**Hoback
Junction**

finding of no significant impact

WYDOT Project Numbers:
N104006 | N104065 | N104078

FHWA-WY-FONSI-2007-03

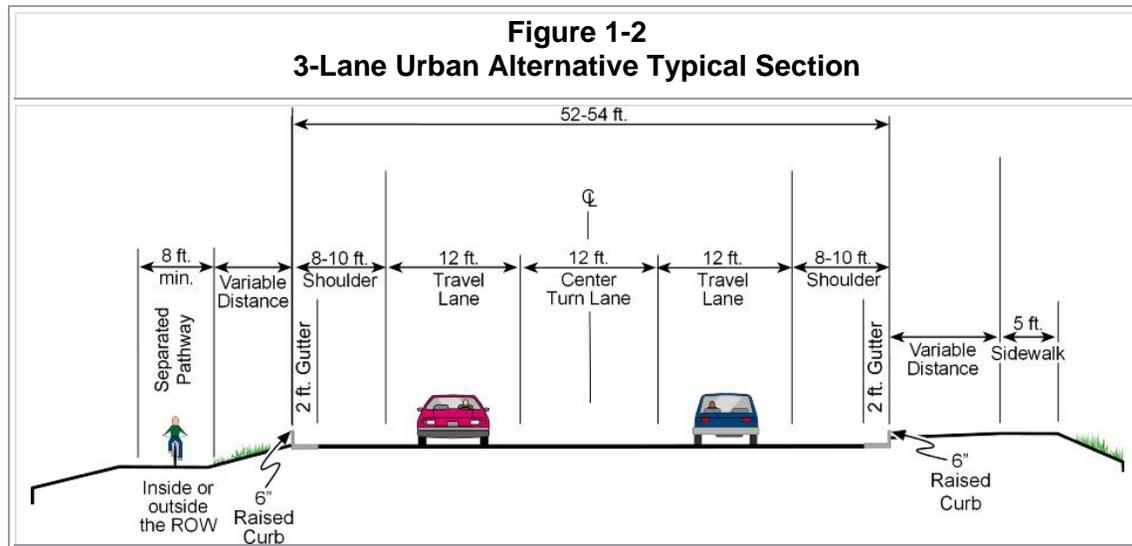
Friends of Pathways generally supports the proposed 3-lane urban road section proposed in Hoback Junction. One specific improvement we suggest is changing the proposed 5' sidewalk on one side into a 10' wide pathway for pedestrian and bike use, so the design would have a 10' pathway on both sides. The Hoback Junction main commercial area has a substantial 200' wide right-of-way along the commercial downtown, which should provide adequate room for the preferred alternative three lane urban section and the addition of a 10' wide pathway for shared pedestrian and bicycle use on both sides. The width of the preferred alternative road shown is 52-56' wide (Figure 2-3 says 52-54'). That still leaves ample room for internal circulation and a pathway on both sides.

Friends of Pathways has consistently commented that pathway standards in Teton County are 10' wide, not the "8' minimum" shown on the EA typical sections. I recently attended the public meeting at the WYDOT Jackson Office and discussed this again with the design team. The typical sections in the EA decision must be revised to show a 10' typical width for shared use pathways. This is supported by the 1999 AASHTO Guide for the Development of Bicycle Facilities, a guide that has been available since prior to the start of this planning process. The AASHTO Bicycle Guide states on Page 35:

There appears to be an opportunity to reduce the width of the auto lanes, and remove the middle turn lane. Obviously, no turns are possible on the bridge. Side road access on the east side should be dealt with without a highly expensive bridge center turning lane that provides no turn movements. Two 12' lanes, two 8' shoulders, and two 6' sidewalks, one each side a minimum 6' width, should be provided. This can be done in 52' as compared to 57' width in the proposed design with 3-12' lanes. This would result in a substantial savings perhaps into the millions of dollars, and a design that would carry the traffic and more safely accommodate pedestrians.

4. New Bridge Design: There is no need for a turn lane on the bridge. How about two 12' lanes, two shoulders, and two sidewalks, one each side a minimum 6' width. This would provide a pedestrian friendly alternative and allow people to view the Snake River.

Hoback Junction Village Comments: Final pathway and sidewalk location and configuration will be determined during final design. WYDOT would provide adequate spacing. WYDOT currently uses the 1999 AASHTO Guide for the Development of Bicycle Facilities. WYDOT agrees with a 10-foot width for a shared use pathway and will construct this width when feasible; however, an 8-foot minimum width may need to be used in certain areas having right-of-way or other constraints.

Response: Thank you for taking time to provide comments on this project. WYDOT currently uses the 1999 AASHTO Guide for the Development of Bicycle Facilities. WYDOT agrees with a 10-foot width for a shared use pathway and will construct this width when feasible; however, an 8-foot minimum width may need to be used in certain areas with right-of-way or other constraints.

The width between the curbs on the bridge will match the top width of the roadway. Although left turns cannot be made on the structure itself, a third lane on the bridge is needed to provide a safe transition to the third lane needed for vehicles turning left into Rodgers Point and into the fire station, and to provide additional room for left-turning vehicles that may queue back onto the bridge. Future maintenance and traffic are other considerations when determining the bridge width. The need for a sidewalk on both sides will be determined during the final design phase.

Bridge Comment: The existing bridge width is 28 feet with two lanes; the new bridge would be approximately 57 feet wide, accommodating three 12-foot lanes, two 8-foot shoulders, and a 5-foot sidewalk. The increased bridge width is necessary to meet current design standards, provide for a safe transition to the third lane needed for vehicles turning left into Rodgers Point and the fire station, provide room for left-turning vehicles that may queue onto the bridge, , and provide for bicyclists and pedestrians. The new bridge would be approximately the same height as the existing bridge. Section 3.21 of the EA discusses measures to minimize visual impacts of the new bridge. WYDOT would study and discuss bridge aesthetics with the public during the final design phase.
